**DATE** 9 December 2016

**REFERENCE No.** 1528407-057-M-Rev0

**TO** EPA Victoria

**FURTHER INFORMATION RE SECTION 22 NOTICE,  
MELBOURNE REGIONAL LANDFILL (MRL) EXTENSION**

Plate 3: Section C extract from Figure 25

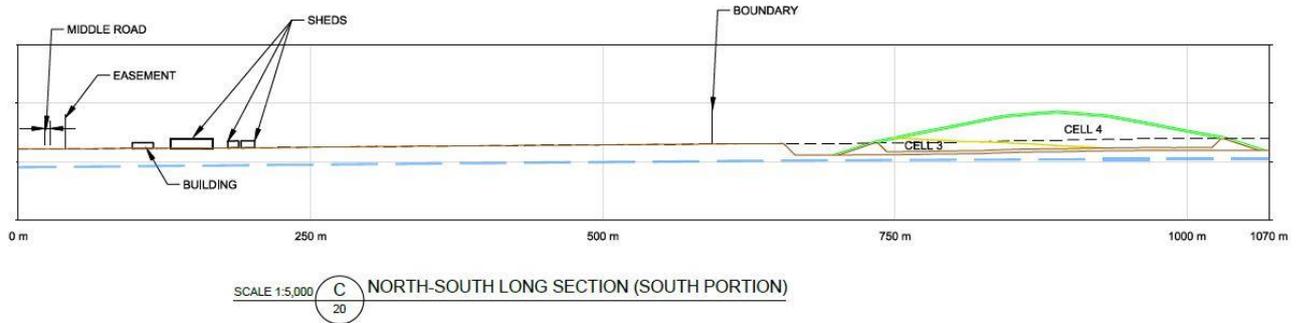
1. Provide an assessment and measures on the geotechnical stability of the side wall and the side wall liners of the landfill, in particular where the landfill does not adjoin the quarry batter. Details are requested of the measures that will be installed to ensure that the geotechnical stability of side walls and the side wall liner will be maintained."

A typical cross section of the proposed landfill has been selected from the South Portion where the landfill does not adjoin the quarry batter, which is equivalent to Section C on Figure 25 (refer Plate 3) and is located as shown on Figure 20 (Refer Plate 4).

A stability assessment has been undertaken using the SLOPE W model. We analysed Cross Section C in the model and applied typical parameters for the engineered soil bundwall, geosynthetic liner materials and waste.

Plate 5: Proposed Groundwater Collection Layer

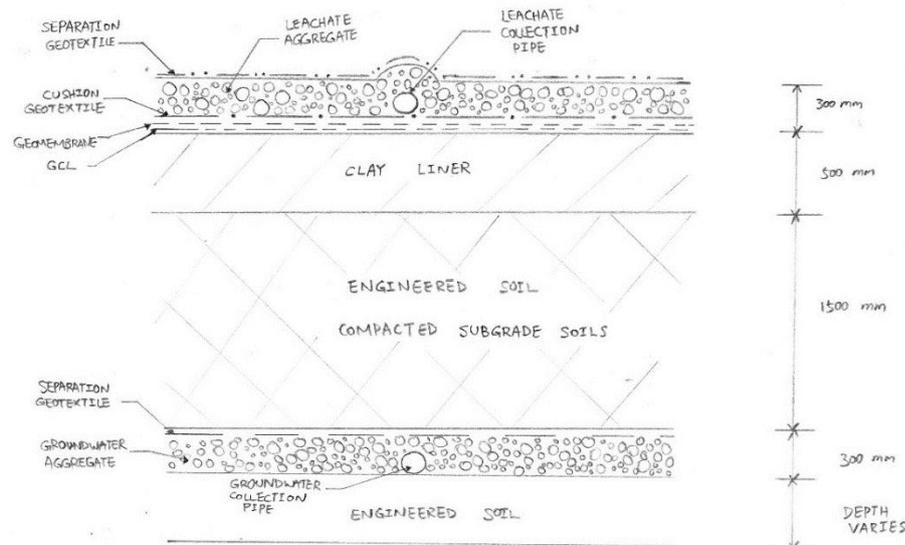
1. *Additional design and management measures. If the information provided in response to (1) Understanding the Baseline Environment above indicates that a 2m separation between waste and the long term undisturbed depth to groundwater is not achieved (for any area within the landfill), please provide additional design and management practices that would be adopted to show compliance of clause 16(2) of the WMP. Note that those measures must be acceptable to the Authority.”*

A groundwater collection layer would comprise of groundwater collection pipes surrounded by groundwater drainage aggregate, which is overlain by a layer of filter geotextile. The groundwater collection layer is to be constructed above the quarry floor within the engineered compacted subgrade soil, which is formed by clearing of the quarry floor followed by placement of an engineered compacted subgrade soil with various depths to shape the ground to promote drainage of groundwater. The spacing of the groundwater pipes would be determined at the detailed design stage prior to licencing the cells, taking account of groundwater conditions, inflow rates and the cell geometry.

Plate 5 presents details of the groundwater collection layer.
